Blacktown City Council assessment report

Sydney West Central Planning Panel

Panel reference	2016SYW057 DA
DA number	JRPP-15-2324
LGA	Blacktown City Council
Proposed development	Integrated development for a 9 stage Torrens title subdivision to create 647 residential lots, 15 residue lots and a future park lot, construction of new roads, a drainage basin and associated drainage channels, and ancillary subdivision works
Street address	Lot 4, Lot 5 and Lot 7 DP 1078187, Lot 10 DP 1178982 and Lot 170 DP 1191299 Richmond Road and Elara Boulevard, Marsden Park
Applicant and owner	Applicant: Stockland Development Pty Ltd Owner: Winten Development Pty Ltd
Date of DA lodgement	23 October 2015
Land zoning:	R2 Low Density Residential RE1 Public Recreation SP2 Infrastructure – Local Drainage SP2 Infrastructure – Local Road E2 Environmental Conservation RU6 Transition Under State Environmental Planning Policy (Sydney Region Growth Centres) 2006
Capital investment value:	\$24,070,758
Regional development criteria (Schedule 4A of the EP&A Act)	CIV exceeds \$20 million

Figure 5 Plan showing context to drainage system and surrounding land (Source: J Wyndham Prince)

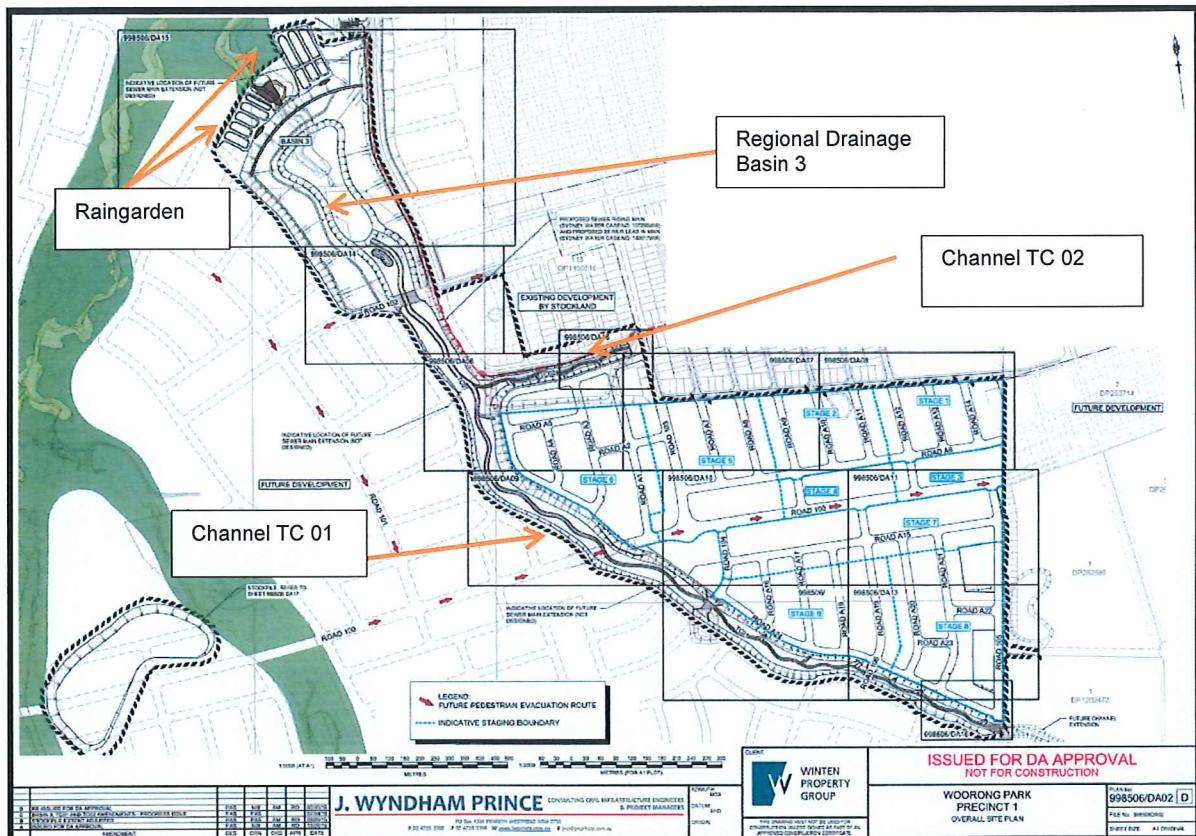
The applicant submitted updated channel and basin sections in November 2016 demonstrating that the road formation for the proposed road along the drainage channel with a shared path situated within the channel (3.5 m verge adjoining the R2 zoned area, 9 m carriageway and 3.5 m verge adjoining the SP2 zoned land) will not compromise hydraulic capacity.

Council's Engineers have recommended that, prior to the issue of a Construction Certificate, the detailed engineering design information and associated reports for regional Detention Basin No. 3, raingardens, channels TC 01 and TC 02 and associated drainage structures be submitted for Council's approval. The information must demonstrate that the proposed road formation will not impact on the function and operation of the regional drainage infrastructure.

Figure 6 Overlay of ILP road network

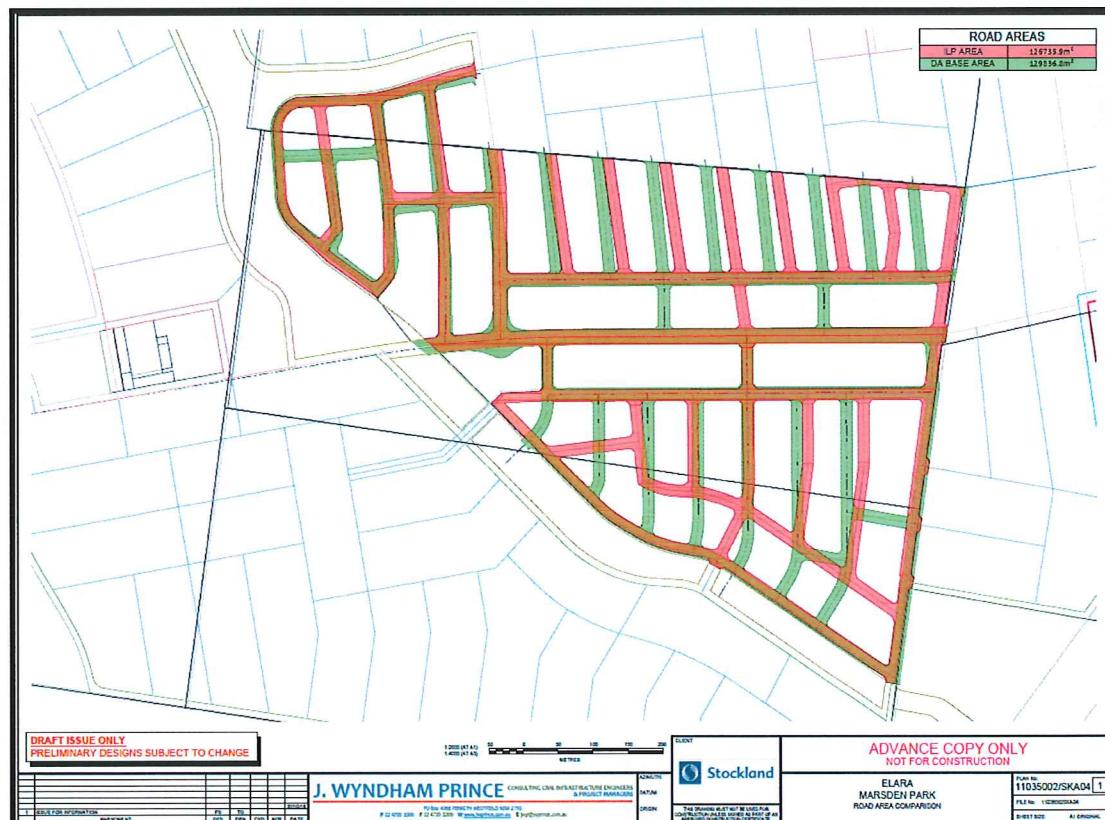
(b) Road pattern of ILP

The applicant also seeks to vary the road pattern of the ILP. In support of the variation, the applicant has submitted an overlay showing the road network as per the ILP (in pink) and the proposed road network (in green) (refer Figure 6 below). The overlay shows that the road areas under the ILP and the proposal are as follows:

Road area
ILP	12,6735 sqm
Proposal	12,9836 sqm

No objection is raised to the variations to the road reserve widths and the road pattern of the ILP for the following reasons:

- (i) The proposed road hierarchy is generally consistent with Figure 4-2 Precinct Road Hierarchy for the Marsden Park Precinct
- (ii) The locations and alignments of all proposed roads will not impede connectivity and accessibility with surrounding development, particularly to the north and east

- (iii) It promotes connectivity between the future residential development and non-residential uses in the locality, promotes cycling, solar access and surveillance to adjoining open space and drainage land

- (iv) The proposed road network still maintains a modified grid that has consideration for the topography and drainage of the site
- (v) The applicant has demonstrated that the variation to the road layout will not impact on the minimum residential density required. The minimum dwelling density as required under the SEPP is still achieved
